Re: Tampa Electric Company  
Polk Power Station Plan of Study

Re: Tampa Electric Company  
Polk Power Station  
Environmental Licensing Plan of Study

Re: EPA Review of Tampa Electric Company's (TEC) Final Environmental  
Licensing Plan of Study (POS) and TEC Responses to EPA Comments of  
the Draft POS; TEC Proposed Polk Power Station, Polk County, Florida

RESPONSES TO THE FLORIDA DEPARTMENT OF  
ENVIRONMENTAL REGULATION (FDER) COMMENTS ON  
TAMPA ELECTRIC COMPANY (TEC) POLK POWER STATION (PPS)  
DRAFT PLAN OF STUDY AND AIR MONITORING PLAN

Water Level Data

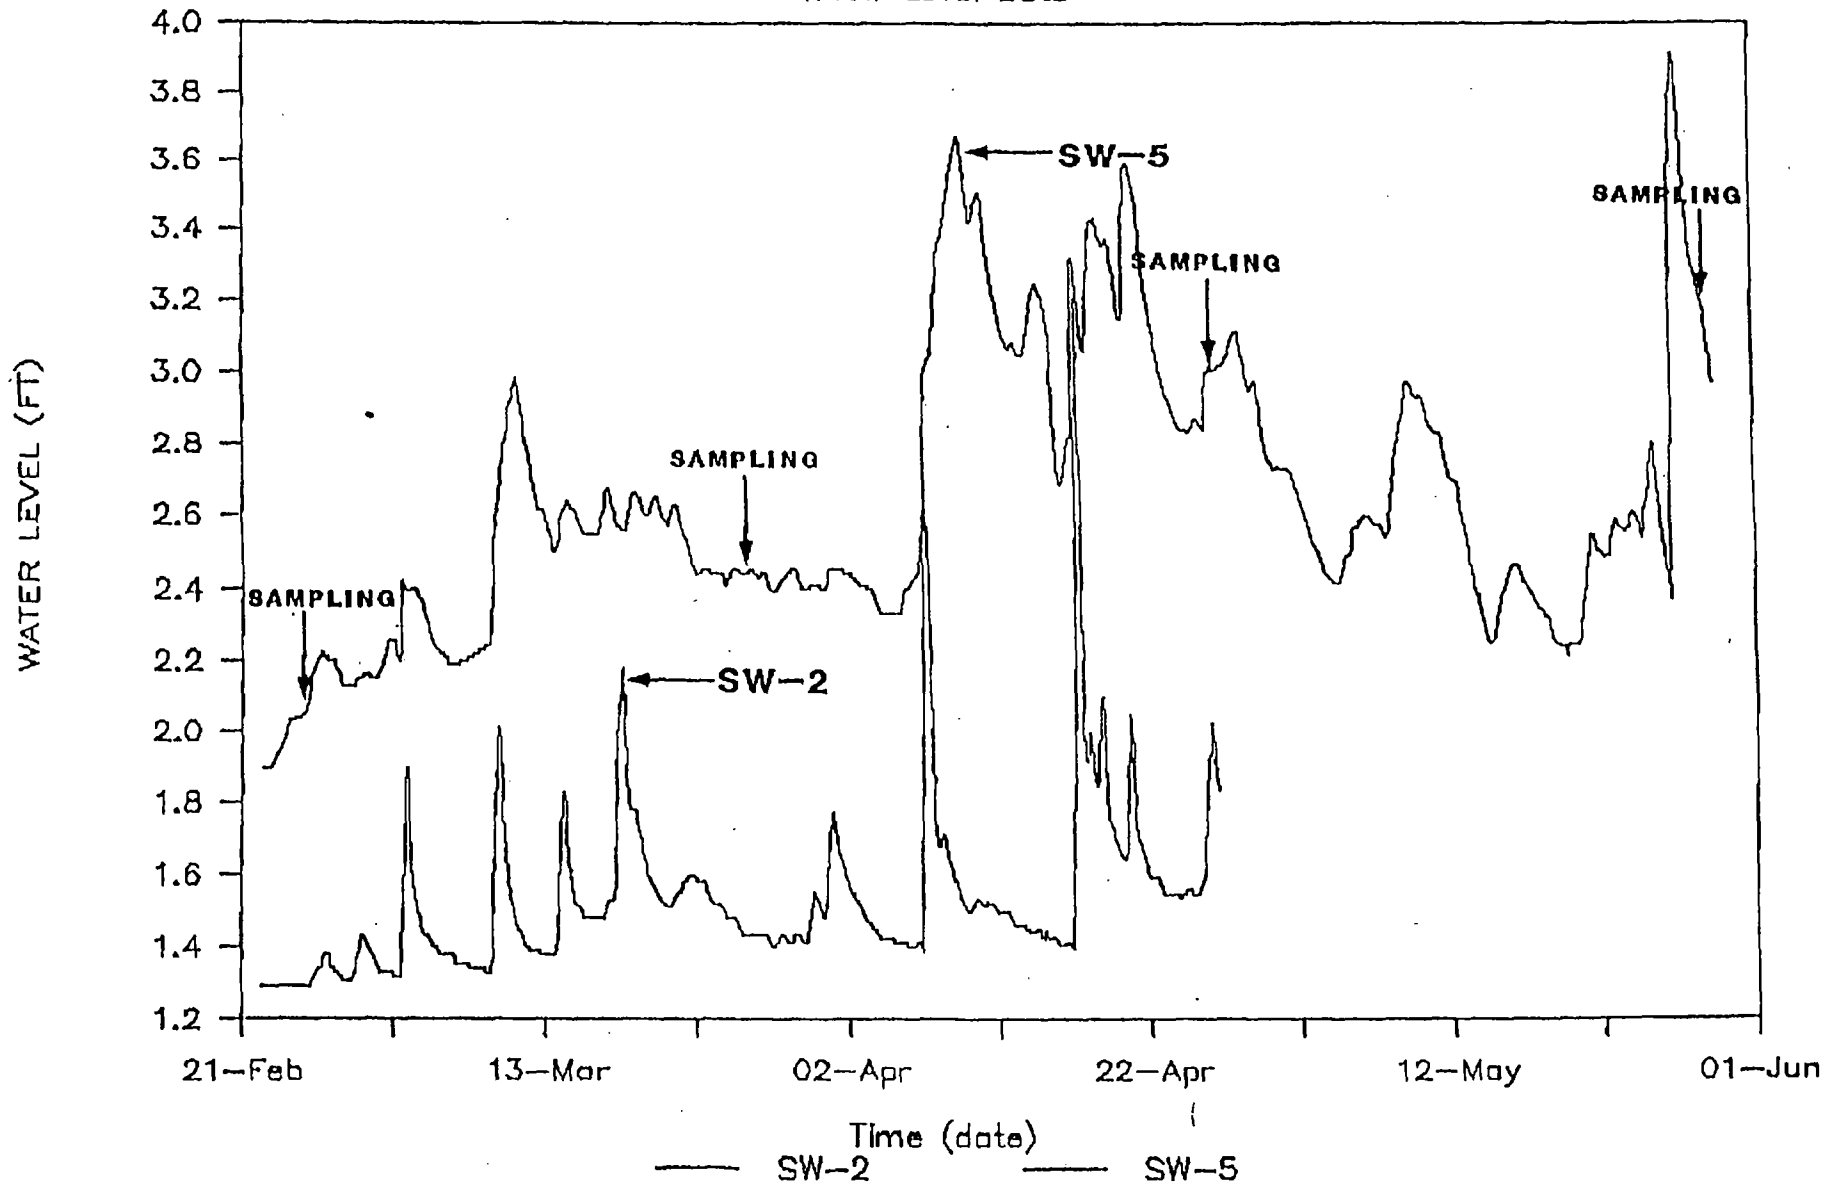
In addition, continuous water level recorders at the site (see Figure 1) show that the February 25 and March 26 water sampling efforts did not have the direct influence from significant rainfall; on the other hand, the April 26 and May 29 samplings were conducted immediately following significant storms. Therefore, the data already collected would be able to characterize the stormwater runoff quality.
